ENGINE - FUEL AND CONTROL - FUEL AND CONTROL - REWORK THE PS3 BURNER AIR TUBE ASSEMBLY TO INCORPORATE ENLARGED MOISTURE TRAP DRAIN HOLES - CATEGORY CODE 4 - MOD.ENG-73-0011

V2500-ENG-73-0011

Moisture Traps in the PB Air Tubes (Fuel System Air Tubes) - Before alteration
Fig.1 Sheet 1 of 2

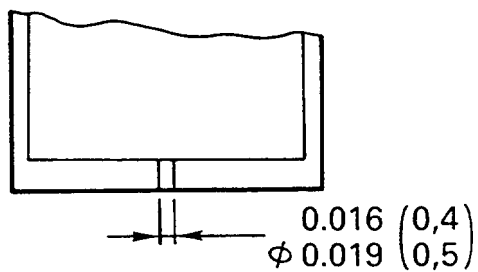
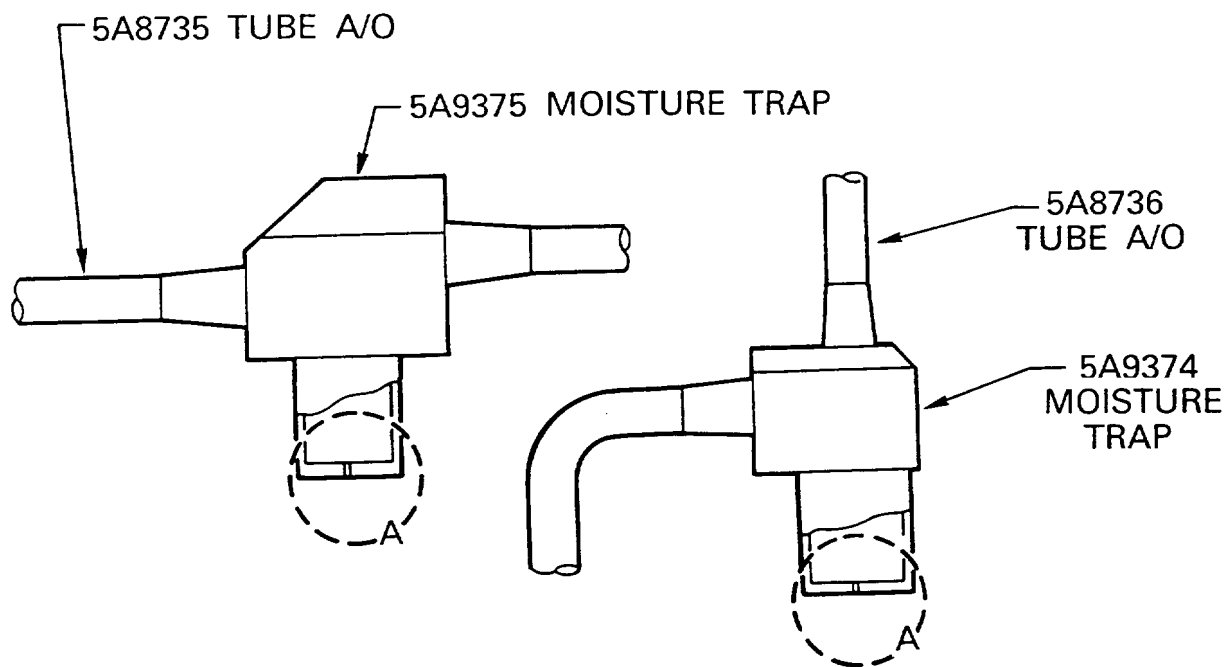
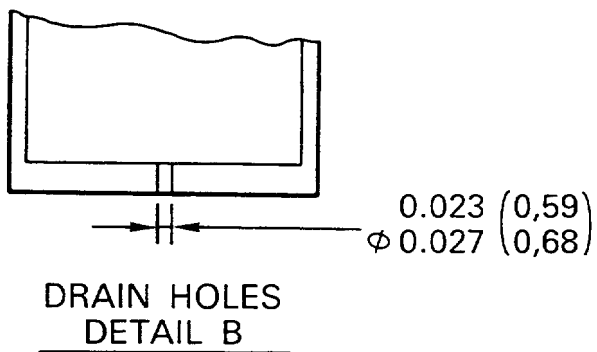
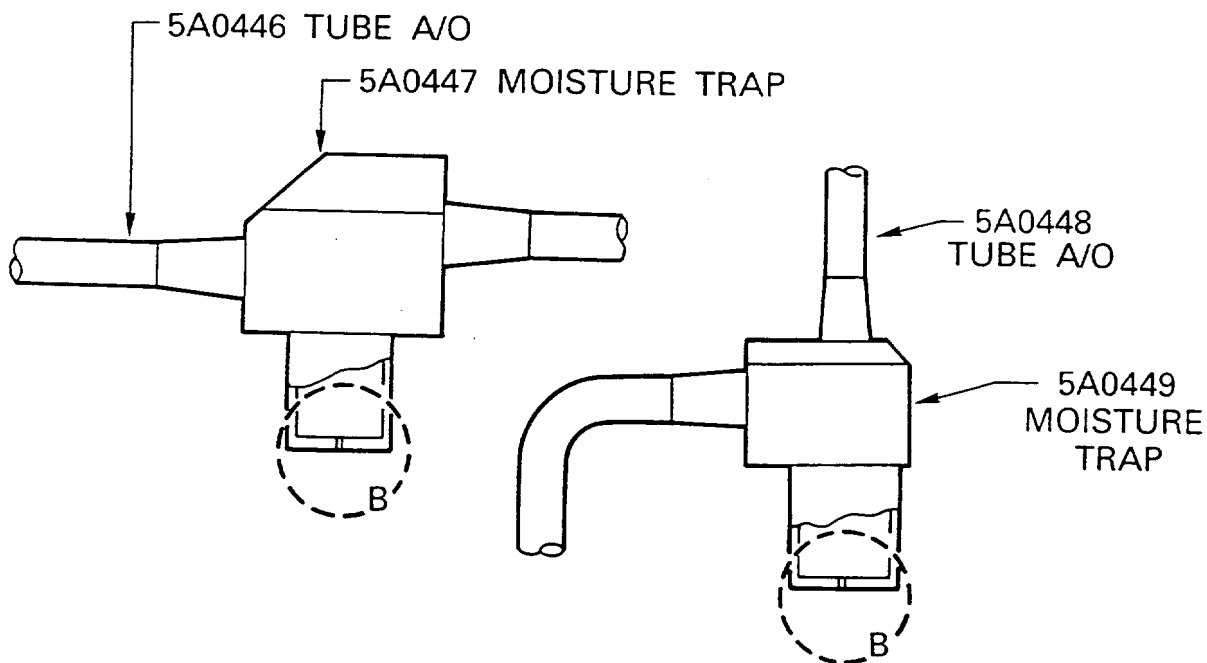
- (a) The diameters of drain holes in the Moisture Traps in PB Air Tubes are increased from the existing 0.016 – 0.019 in. (0,4 – 0,5 mm) in diameter to the new 0.023 – 0.027in. (0,59 – 0,68 mm) in diameter to improve drainage of moisture/water in the PB Air Tubes. (See Figure 1).
- (b) The existing Part Numbers of the Tube A/O's and the Moisture Traps are changed to the new Part Numbers.

Rework of the PB Air Tubes
Fig.3 Sheet 2 of 3

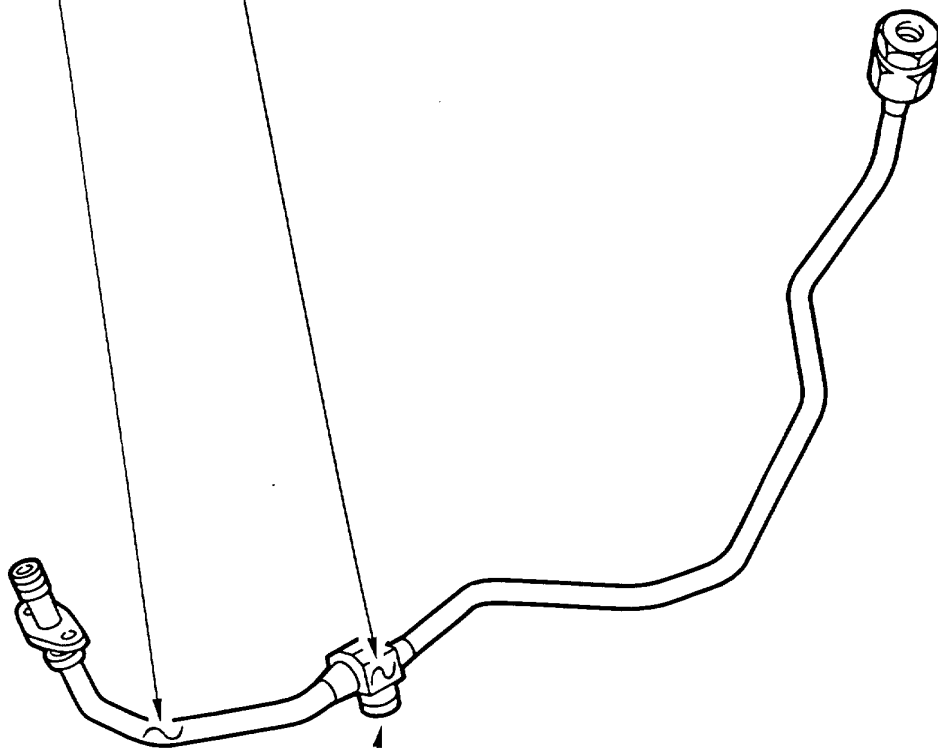
MARK NEW PN 5A0446 BY ELECTROCHEMICAL ETCHING ADJACENT TO EXISTING PN 5A8735 IDENTIFIED HERE.

MARK NEW PN 5A0447 BY VIBRO-PEEN ADJACENT TO EXISTING PN 5A9375 IDENTIFIED HERE.

INCREASE A DIAMETER OF THE DRAIN HOLE FROM EXISTING 0.016 - 0.019 in. (0,4 - 0,5 mm) IN DIAMETER TO NEW 0.023 - 0.027 in. (0,59 - 0,68 mm) IN DIAMETER WITH THE ELECTRIC DISCHARGE MACHINE (EDM).

Rework of the PB Air Tubes
Fig.3 Sheet 3 of 3

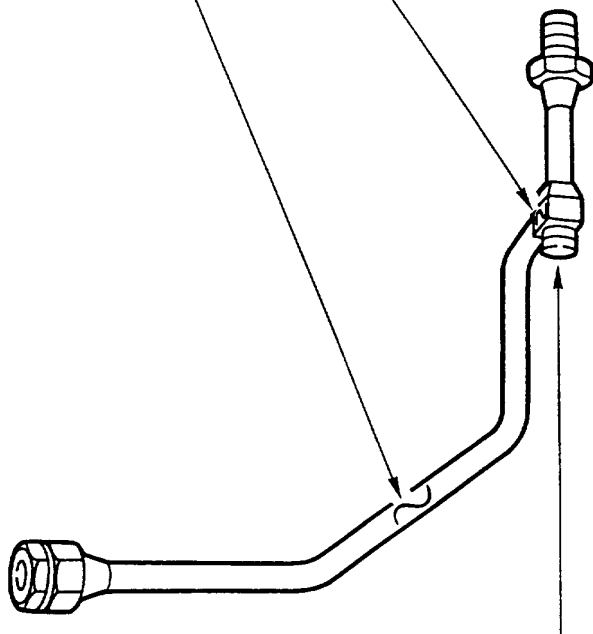
MARK NEW PN 5A0448 BY ELECTROCHEMICAL ETCHING ADJACENT TO EXISTING PN 5A8736 IDENTIFIED HERE.

MARK NEW PN 5A0449 BY VIBRO-PEEN ADJACENT TO EXISTING PN 5A9374 IDENTIFIED HERE.

INCREASE A DIAMETER OF THE DRAIN HOLE FROM EXISTING 0.016 - 0.019 in. (0,4 - 0,5 mm) IN DIAMETER TO NEW 0.023 - 0.027 in. (0,59 - 0,68 mm) IN DIAMETER WITH THE ELECTRIC DISCHARGE MACHINE (EDM).
